UNITED STATES
NUCLEAR REGULATORY COMMISSION
WASHINGTON, D. C. 20555

Docket Nos.: 50-329/330

APPLICANT: Consumers Power Company
FACILITY: Midland Plant, Units 1 and 2
SUBJECT: SUMMARY OF THE MAY 23, 1980 MEETING ON PRESERVICE FAILURE OF
THREE REACTOR VESSEL HOLD-DOWN STUDS

LATERAL SUPPORT PLAN

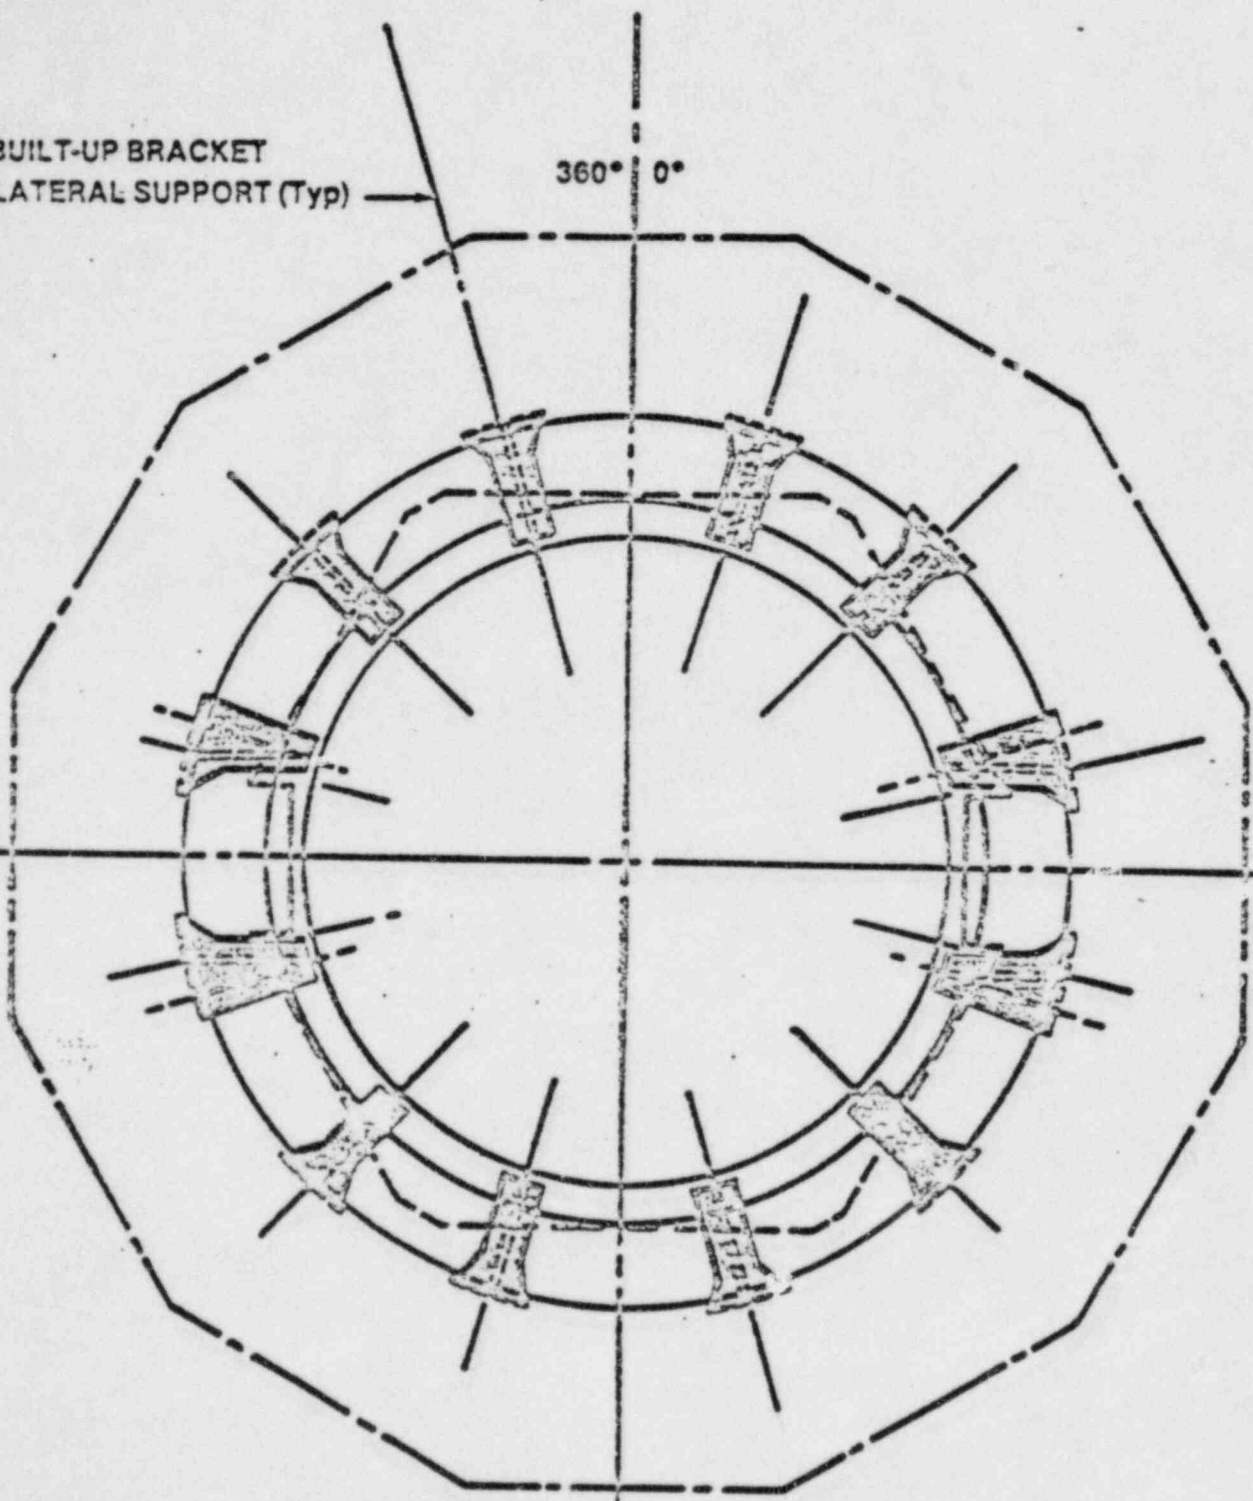
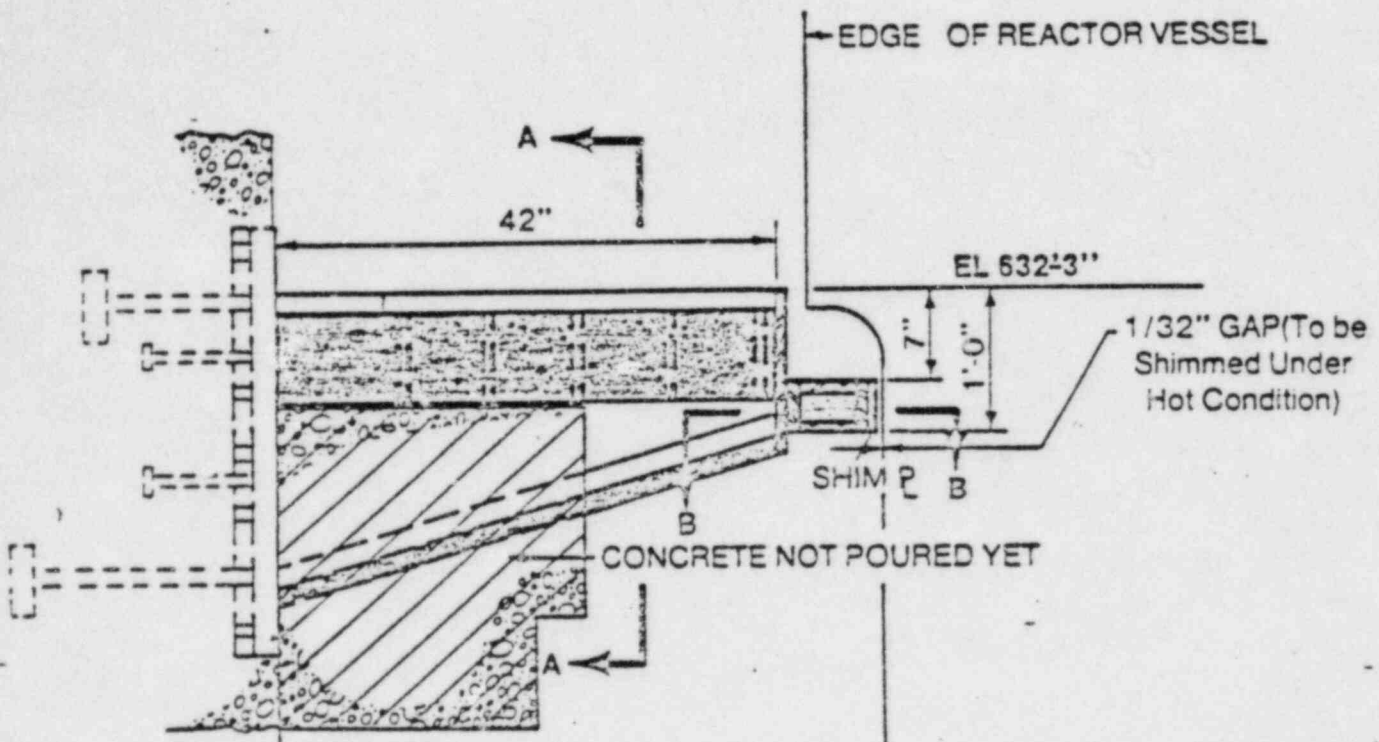
The applicant noted that the stud deficiency for Unit 1, if not corrected, could adversely affect plant safety. Therefore, for Unit 1, the applicant proposes to detension the remaining studs and to modify the vessel support concept so that the studs are used, but are subjected to reduced service stress. The revised support concept would modify the existing A-36 shield plug support brackets which would be shimmed tight (a 1/32 inch hot gap) to the reactor vessel to achieve additional lateral support. The revised concept is shown in Slides 7, 8 and 9.

By the end of June, the applicant will submit a report describing the revised design to achieve additional lateral support of the vessel, including the design allowable stresses to be used.
